UNITED STATES PATENT AND TRADEMARK OFFICE

APPLICATION NO.	FILING DATE	FIRST NAMED INVENTOR	ATTORNEY DOCKET NO.	CONFIRMATION NO.
09/971,131	10/04/2001	James C. Tuthill	21488/04040	4066

Office Action Summary	Application No. 09/971,131	Applicant(s) TUTHILL, JAMES C.	
	Examiner Brian Walsh	Art Unit 3722

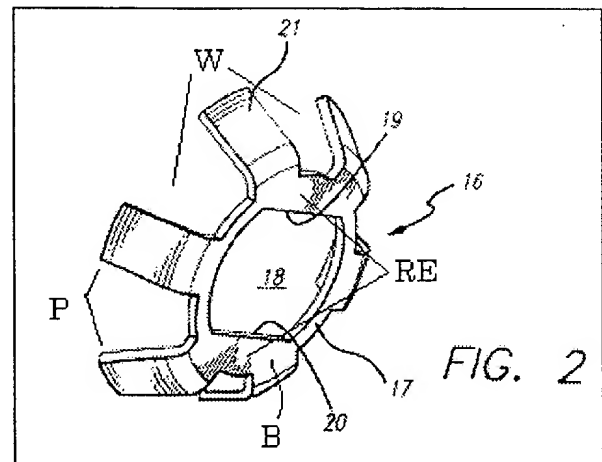
In claims 3, 9 and 14, the Examiner contends that the phrase “D-shaped” is unclear. In claim 11, the Examiner notes that the use of the limitation “T-shaped” is unclear. It is possible for the limitations “D-shaped” and “T-shaped” aperture to be interpreted in a number of ways. The Examiner notes that the aperture, as shown in figures 2 and 3 as (27) and (34), appears to be a truncated circular aperture. Claims 3, 9, 11, 14 and 15 will be examined as best understood.

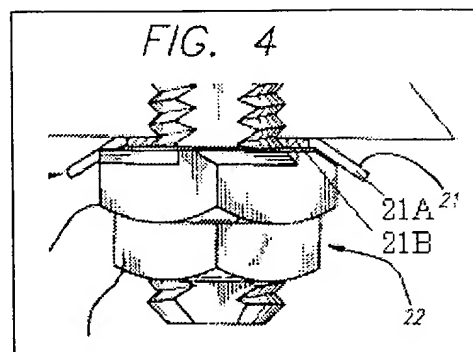
configuration. Duran also discloses the base section (B) defines a central aperture (18) and wherein the peripheral section (P) includes a plurality of fingers (21) which define one or more longitudinal windows therebetween. The fingers (21) include nut engaging surfaces on the interior surface of the peripheral section. It is clear from figure 2, Duran further discloses the fingers include a flared end bent towards the center of the spindle nut retainer.

Regarding claim 2, it is clear from figures 4 and 10 that Duran discloses the nut engaging surfaces each comprise two angled surfaces (21A, 21B). Please refer to a partial capture of figure 4 to the right.

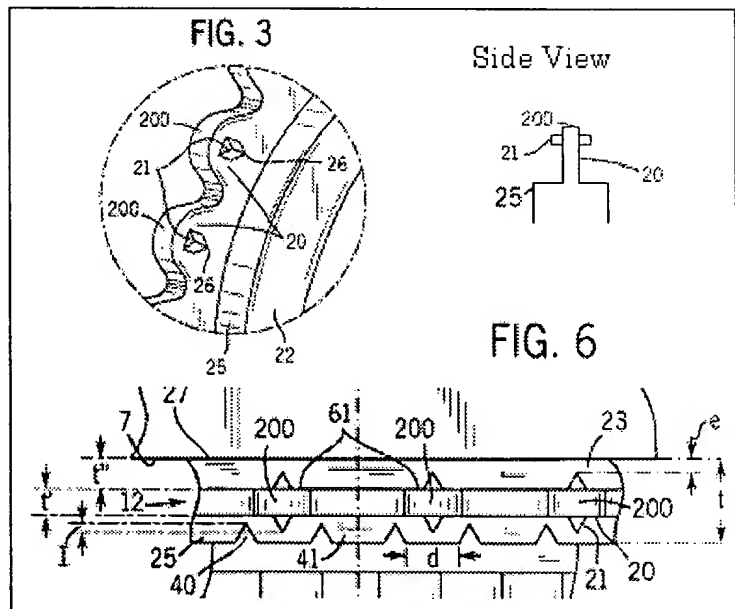
Giachinta et. al. discloses a retainer (12) for preventing disengagement of a nut (14) to a base (2). Giachinta et. al. discloses a peripheral section (200 in figure 3) including an integrally formed ring (25 in figure 3) at an end opposite the base section (23 in figure 6).

Giachinta et. al. discloses a retainer (12) for preventing disengagement of a nut (14) to a base (2). In figures 3 and 6, it is clear that Giachinta et. al. discloses the fingers (200) have protrusions (21) on both a first and second side. When seen from a transverse view, the fingers would appear to have a "T-shape." Please see the attached drawings.
